**Re: Proposed Order No. R1-2016-0004 Waste Discharge Requirements for Nonpoint Source Discharges and Other Controllable Water Quality Factors Related to Timber Harvesting and Associated Activities Conducted by Humboldt Redwood Company, LLC in the Upper Elk River Watershed, Humboldt County**

Humboldt Redwood Company (HRC) appreciates the opportunity to comment on the Draft Waste Discharge Requirements (WDRs) proposed for HRC's forestry and watershed management operations in the Upper Elk River Watershed (Order No. R1-2016-0004; August 30, 2016).

**Subject: Hydrologic Review of THP 1-16-056 HUM**

Figure 2. The route taken by the Review Team in Unit 2.

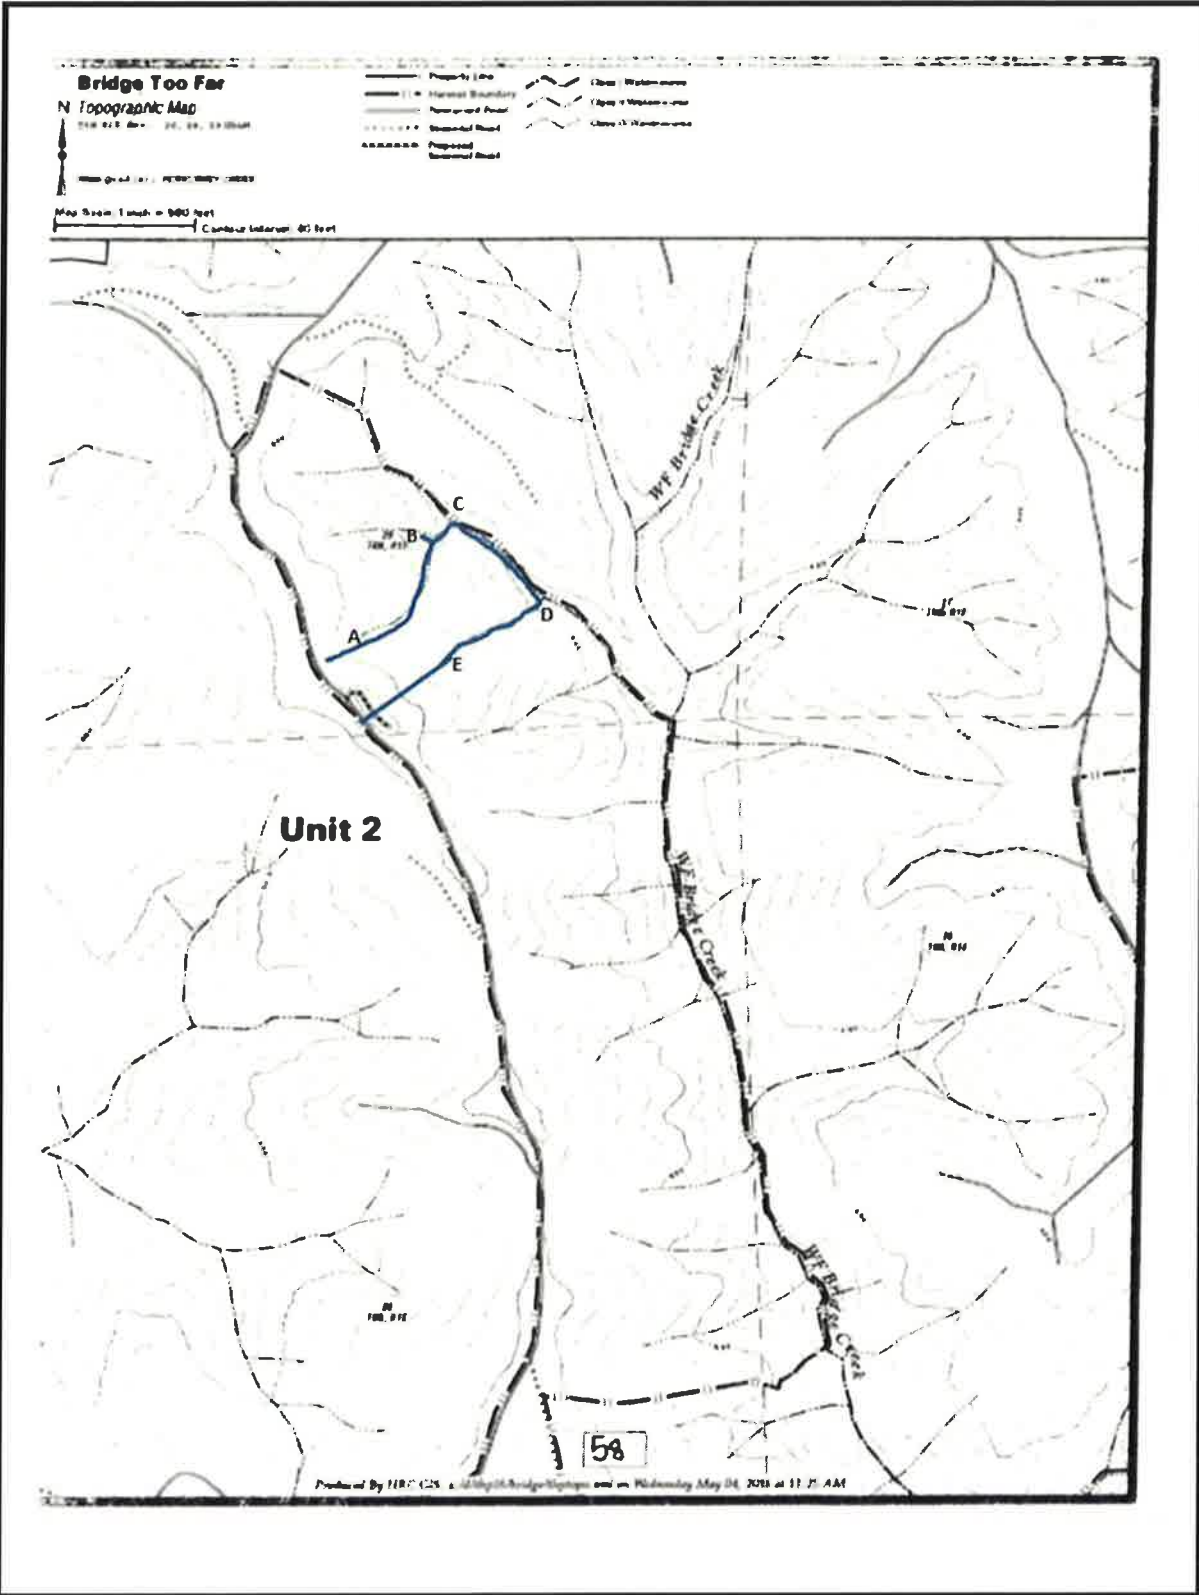
1-16-056 HUM - Unit 2: Unit 2 is a large selection harvest unit which is proposed to be cable logged. The field PHI Team (Team) walked down to the channel head of the first order (Strahler, 1957) Class III watercourse shown in Figure 2 (see point A). The location of the channel head appeared to be properly identified as no channelized flow was observed above where the channel head was flagged. The area where the channel head was located can be characterized as hydraulically rough due to the prevalence of live vegetation, thick layers of duff, and a relative abundance of large woody debris (Figure 4). Below the channel head, the watercourse was discontinuous, relatively entrenched, with generally subvertical and well vegetated banks. The channel exhibited a relatively steep and stepped profile with generally subvertical discontinuities (i.e., headcuts) present. Channelization was discontinuous, with subsurface channelization/piping occurring in conjunction with large woody debris (Figure 5) and thicker accumulations of colluvium and/or anthropogenically-induced valley infilling from first cycle logging.

The Team continued down to the confluence of two Class III watercourses (Figure 2; Point B), where the watercourse became a second order channel. Below the confluence the watercourse displayed slightly more consistent signs of channelization. However, valley gradient, the condition of the banks, and the roughness of the channel did not change significantly. The second order Class III watercourse combined with another second order Class III watercourse to form a third order Class III watercourse (Figure 2; Point C). This larger third order Class III watercourse was characterized by a much gentler valley gradient, a broader valley bottom (Figure 6), but largely remained a discontinuous channel. Watercourse banks were well vegetated and did not show signs of active erosion, although there was evidence of subsurface flow and/or erosion voids along the axis of the channel, particularly in areas with larger accumulations of large woody debris (Figure 7).

The third order Class III watercourse transitioned into a Class II watercourse shortly above point D on Figure 2. This transition appeared to be accurately identified by the RPF. At point D, the Team walked up a first order Class III watercourse. This watercourse displayed similar characteristics and conditions to that of the first watercourse walked between points A and B (Figure 2). The Team continued to walk the watercourse until the channel head was reached (Point E, Figure 2). The channel head at point E was very similar to the one discussed for point A (Figure 2).

**Figure 3.** Points indicating the locations inspected in Unit 1.

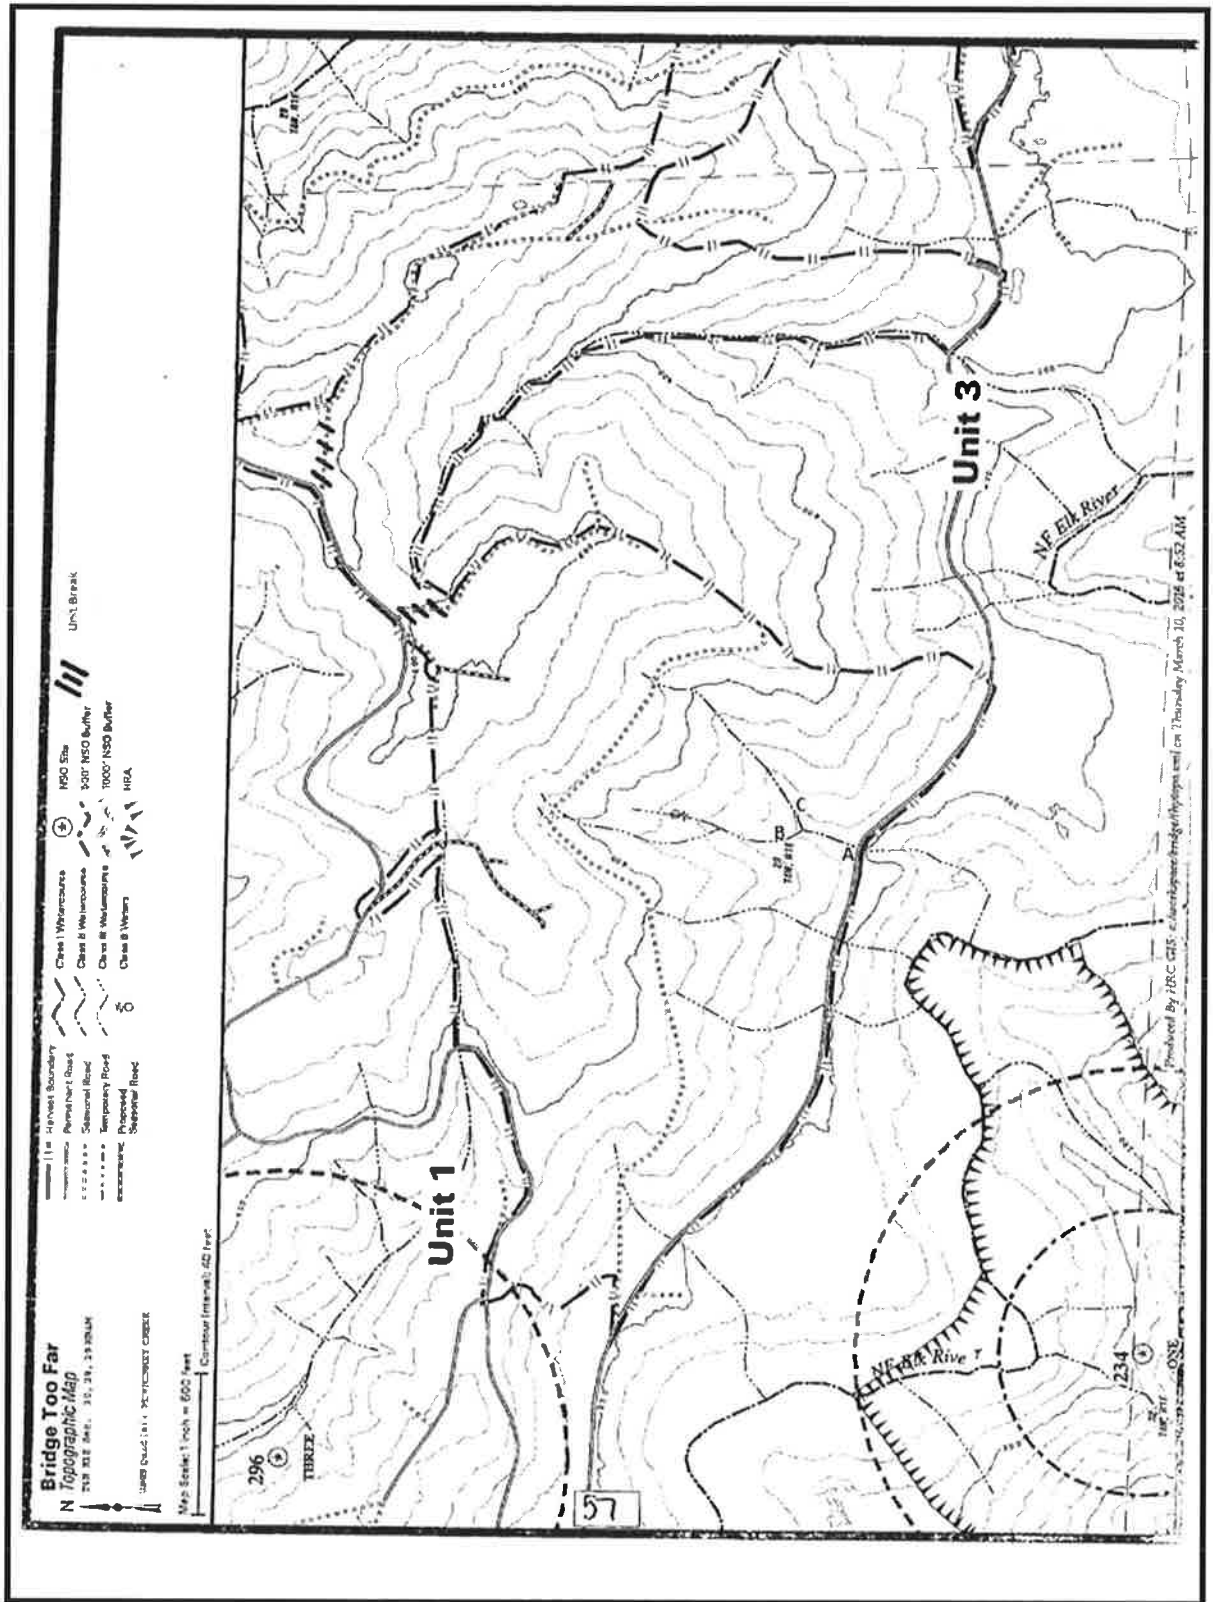
1-16-056 HUM - Unit 1: The Team walked up the Class II watercourse shown in Figure 3 (Point A). The portion of the Class II watercourse directly above the road displayed active erosion and incision, and this was primarily attributed to base level lowering associated with watercourse crossing replacement. Above the influence of the watercourse crossing, the watercourse displayed no signs of recent erosion. The Team continued up to the confluence of a second order Class III watercourse (Figure 3; Point B) and a first order Class II watercourse (Figure 3; Point C). No recent in-channel erosion was observed in either watercourse, although evidence of an old skid trail fill failure was observed adjacent to Point C (Figure 3). The old failure is contained within the RMZ of the proposed THP.

### **Recommended 'High Risk' Sub-Watershed Delineation reflecting Actual Location of Hookton Formation and related Alluvium and Marine Terraces**

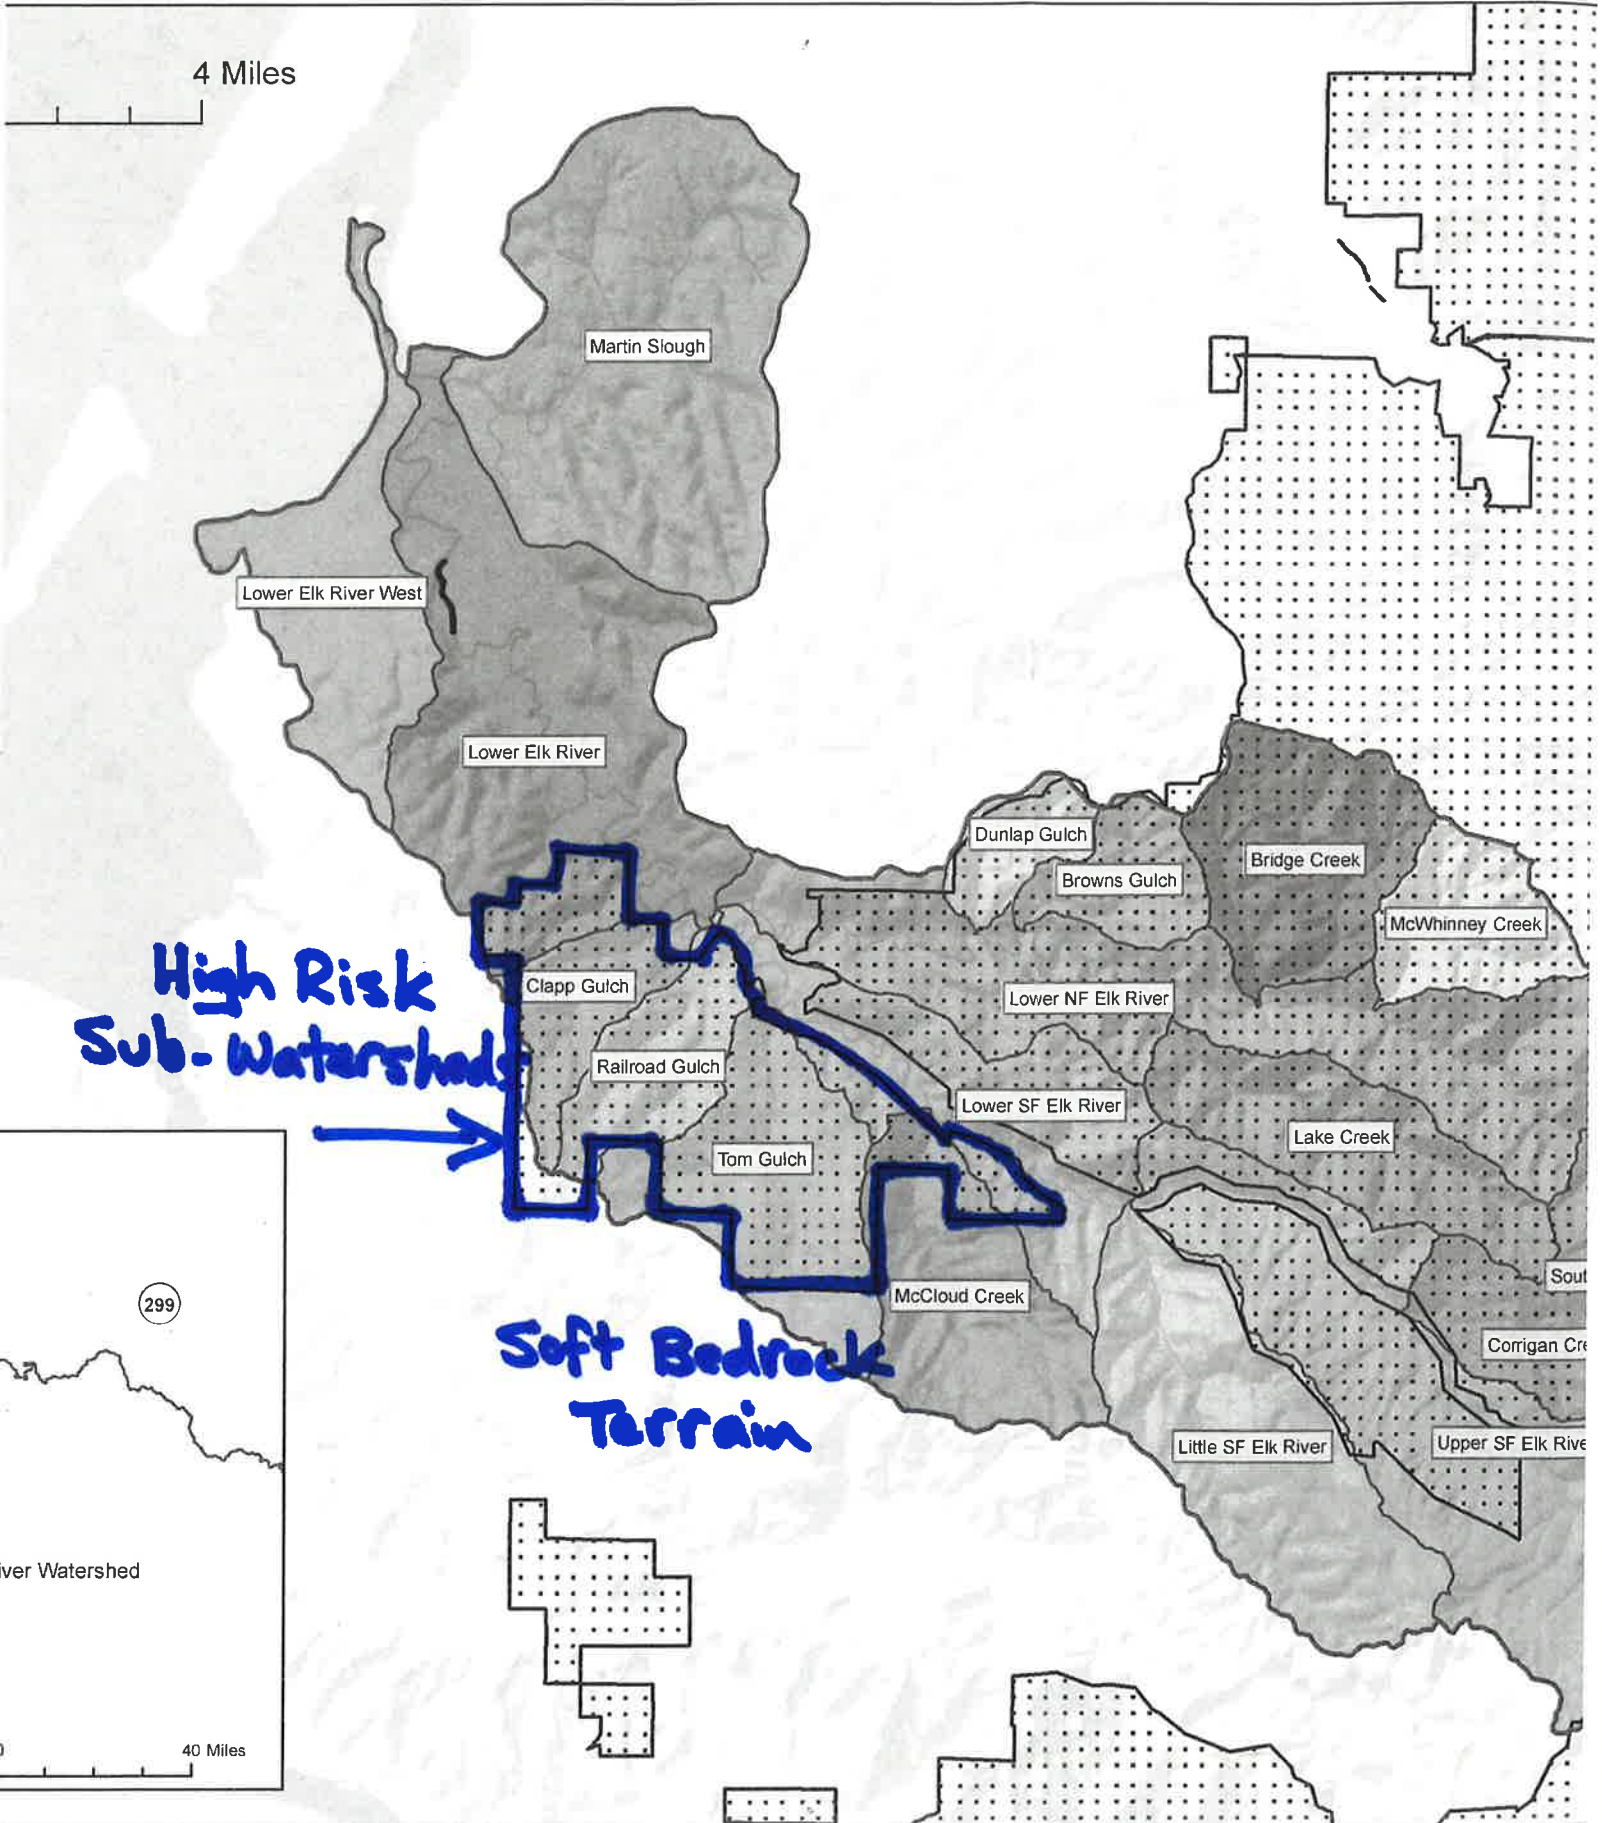
HRC recommends that the delineation of the 'high risk' sub-watersheds be corrected prior to the adoption of the WDRs so as to accurately reflect the actual location of the softer bedrock terrain Hookton Formation, marine terraces, and alluvial deposits, as recently discussed with NCRWQCB Supervising Unit Timberland Chief, Jim Burke. Please refer to the attached map found as Appendix C for an accurate delineation of the lithologies of concern per Licensed Geologist, Shane Beach.
